SERVICE BULLETIN

ALL LEGACY, SVX AND IMPREZA MODELS
EQUIPPED WITH 4EAT TRANSMISSION

03-08-94

SUBJECT: 4EAT MODIFICATIONS

4.) TRANSFER CLUTCH DRIVEN PLATES AND OIL SEALS

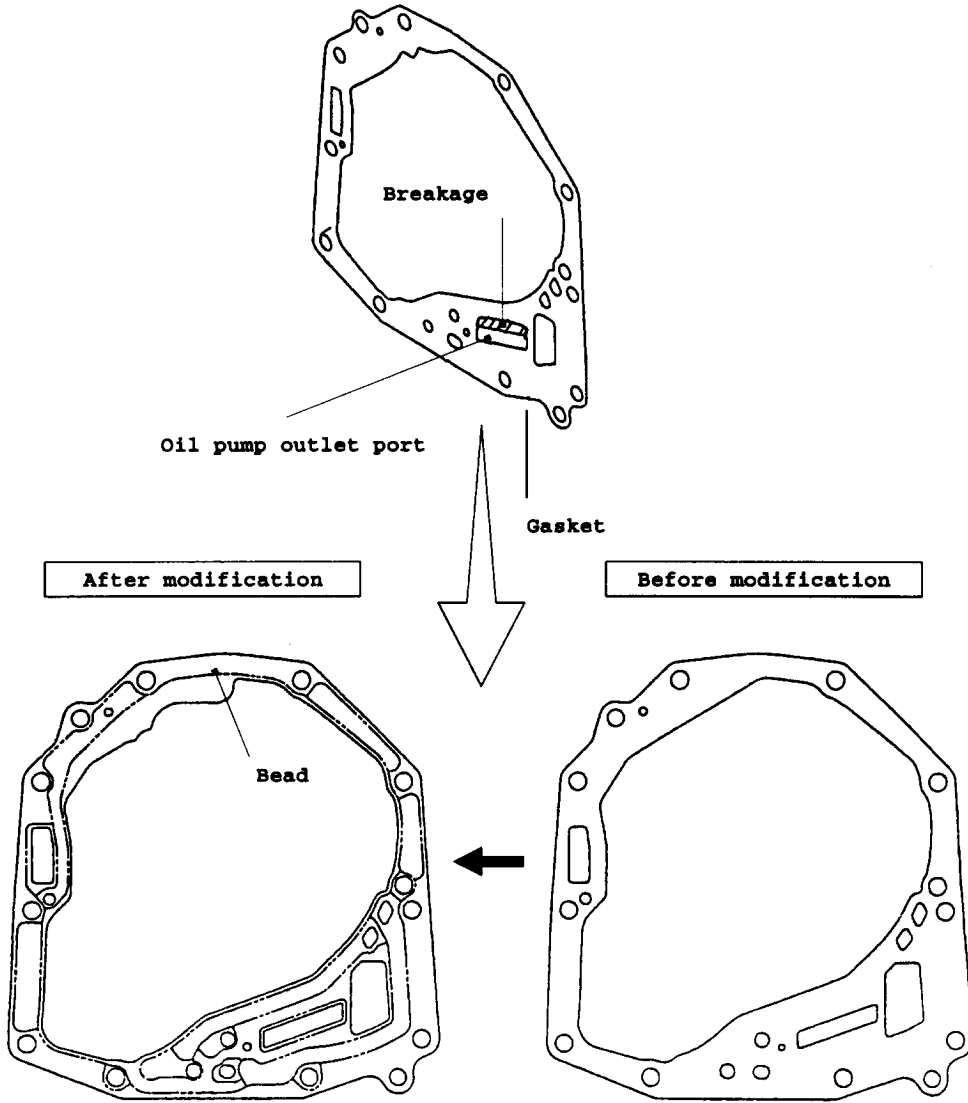
4. Transfer Clutch Driven Plates (Metal) and Seal Rings - Refer to Figure 4

Modified Clutch Driven Plates (P/N 31589AA041) were installed to reduce rear axle binding starting with transmission number 389607. Additionally, new style Oil Seals (P/N 31377AA131) have been installed on the transfer clutch output shaft. These updated seals are black in color with a "notched" design on their inner diameter and are cut diagonally on the ends. The purpose for the change was to reduce the chance of these seals rotating in their grooves and cutting into the rear extension housing.

If you experience a case of rear axle binding on turns, with a transmission that has the updated transfer clutch driven plates, it is recommended that you install another set of the updated driven plates. After installing these new driven plates, it will be necessary to drive the vehicle in several figure 8's to break them in. As always, the first thing to check when diagnosing an AWD binding complaint is tire size. All tires must be of the same size and brand name.

1.) OIL PUMP GASKET

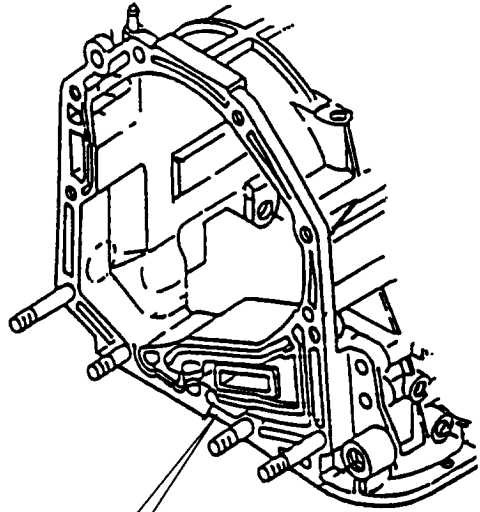
1. Oil Pump Gasket - Refer to Figure 1

The transmission Oil Pump Gasket (P/N 31339AA121) was changed to a metal type gasket to lessen the possibility of gasket deterioration. This gasket was installed in production starting with transmission number 513102/SVX, 527022/Legacy, and since the beginning of production on all Imprezas. This gasket must always be used when gasket replacement is necessary. When using this gasket, the small metal deflector mounted to one of the oil pump cover bolts must be removed (Reference Parts Bulletin PT-26-03-93).

Symptoms of a deteriorated gasket are approximately 1/2 line pressure at idle and full line pressure at stall speed. It may also be accompanied by a delay going into reverse on SVX and Turbo vehicles.

2.) TRANSMISSION CASE

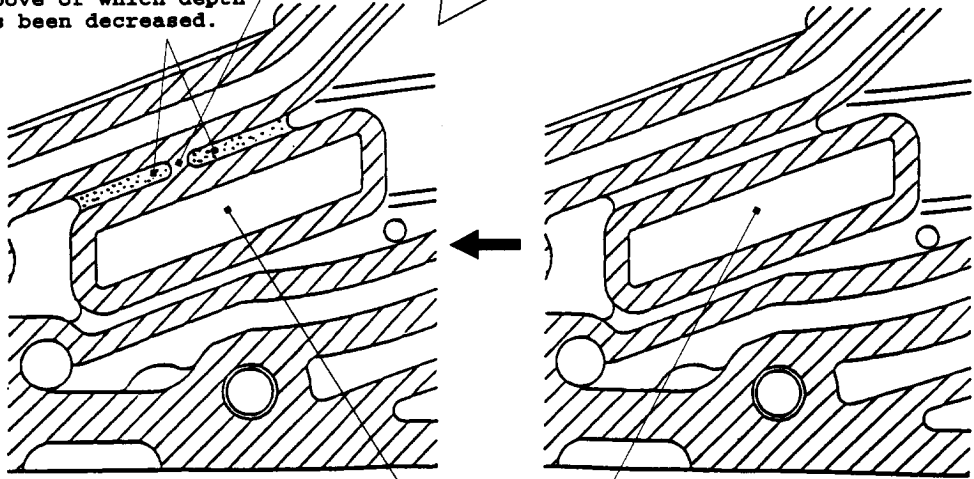
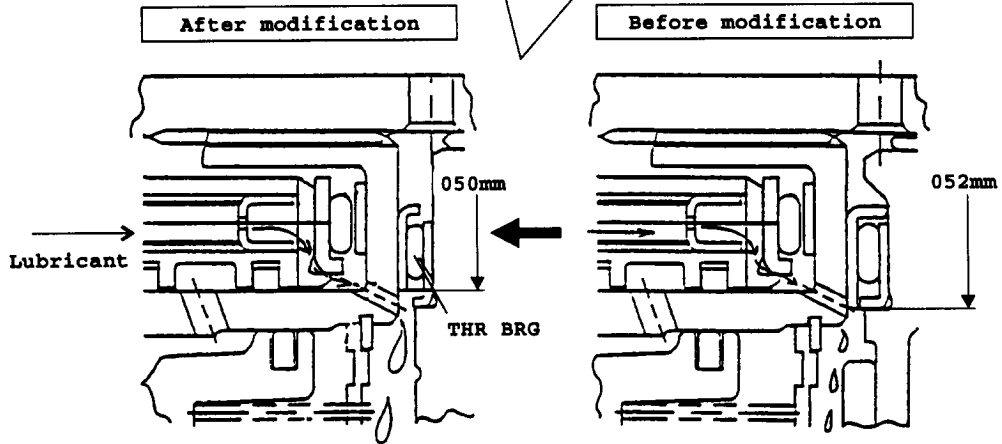
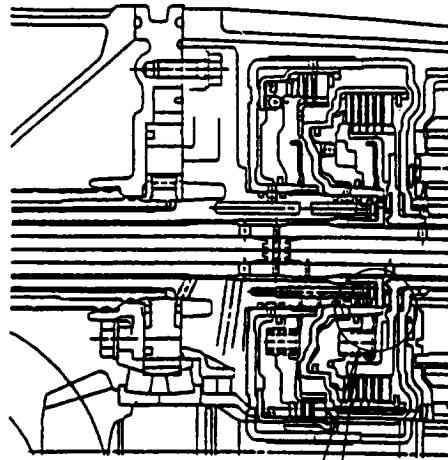
2. Transmission Case - Refer to Figure 2

The transmission case was slightly modified starting with transmission number 426208. Modification was made to prevent oil pump gasket deterioration. Installation of the updated oil pump gasket is all that is necessary to prevent gasket deterioration on these earlier transmission.

Symptoms are the same as with oil pump gasket deterioration in Number 1 above since it will result in a gasket sealing problem. In both cases, oil pressure will be degraded. Other related symptoms may be a delay in starting when the select lever is placed into 'D' and/or 'R' from neutral or park.

Rib
Groove of which depth
has been decreased.

*****TRANSMISSION CASE REPLACEMENT IS NOT NECESSARY AND IS NOT RECOMMENDED*****

3.) HIGH CLUTCH BEARING

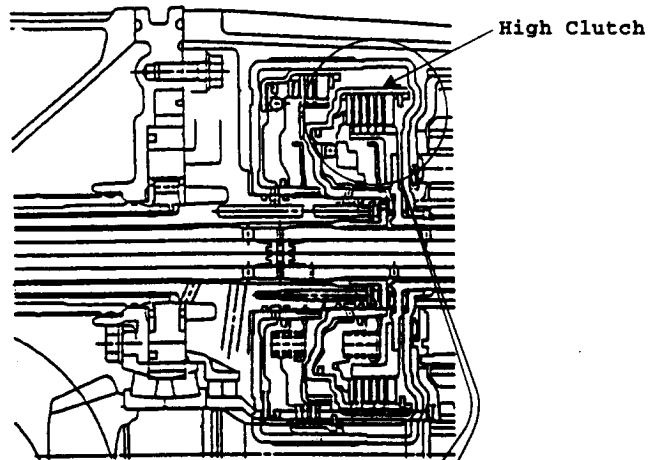
3. High Clutch Seizure/Failure - Refer to Figure 3

Legacy N.A. - Install Thrust Bearing (P/N 80653620) **only** up to transmission number 351299. The diameter of this bearing has been reduced from 52mm to 50mm to ensure adequate lubrication to the high clutch assembly.

3.) HIGH CLUTCH HUB

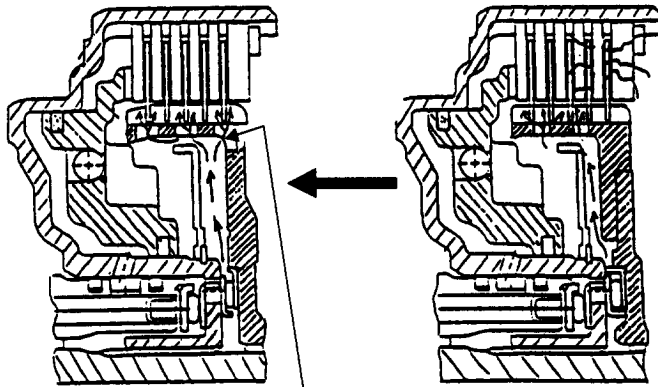
Install High Clutch Hub (P/N 31550AA020) and Thrust Bearing (P/N 806537010) **only** on SVX and Legacy Turbo models up to transmission number 633657 for SVX and transmission number 615173 for Legacy Turbo models.

The modified high clutch hub has additional lubrication holes in it to provide required lubrication to the fifth clutch plate of the high clutch assembly. Recommended repair for a failed high clutch is replacement with the modified part(s) as applicable above.

A lubricant hole has been newly adopted to high clutch hub.
